14A COMMUNICATION SYSTEM  
 (SB4000F LINE CARD - ISSUE 6)

- 1.001 This Addendum supplements Section 518-450-102.
- 1.002 This Addendum is issued to provide information for the use of the SAN/BAR 4000F Line Card in the 14A Communication Systems. For detailed information on installation and testing of the SB4000F Line Card, refer to BSP 518-215-905SW.
- 1.003 Issue A of this Addendum was issued to provide a means to activate the customer's equipment when COAM Paging equipment is used with the 14A Communications System. A 22A-49 apparatus unit is used to provide contact closure to COAM Paging equipment.

EXHIBIT 1

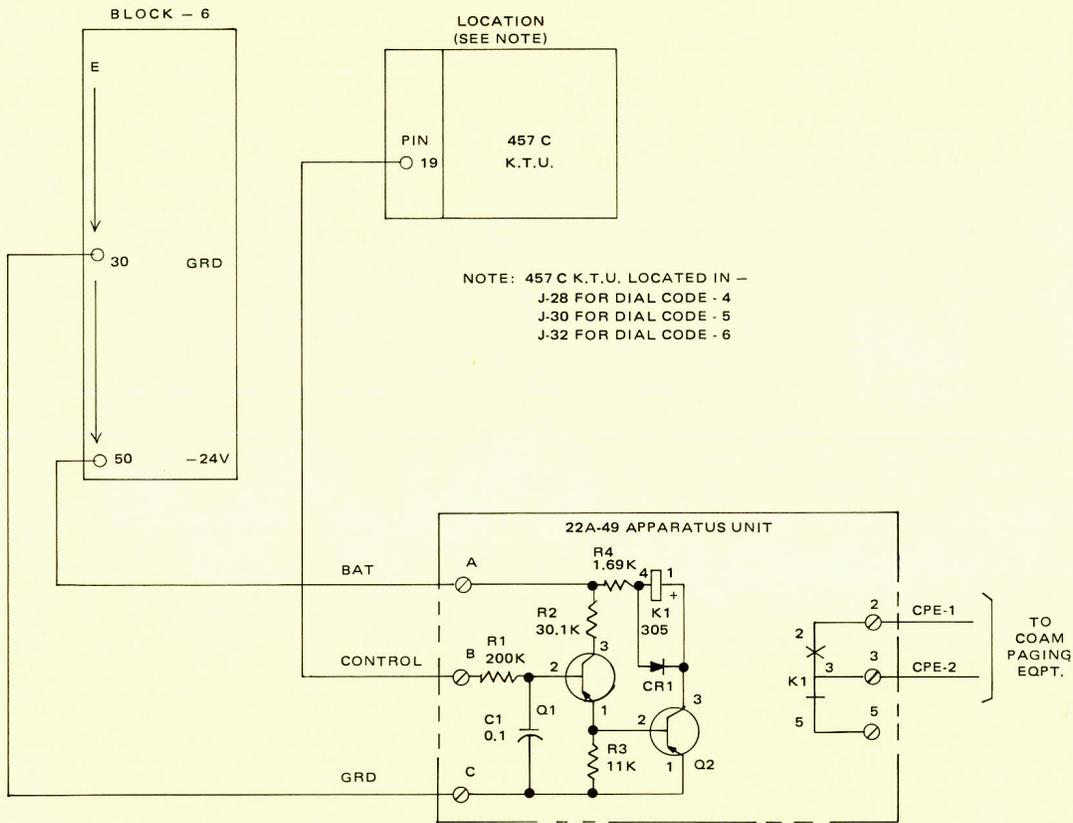
2.001 See Exhibit 1 for connecting arrangements.

Connections for 22A-49 Apparatus Unit  
on COMKEY 1434 System
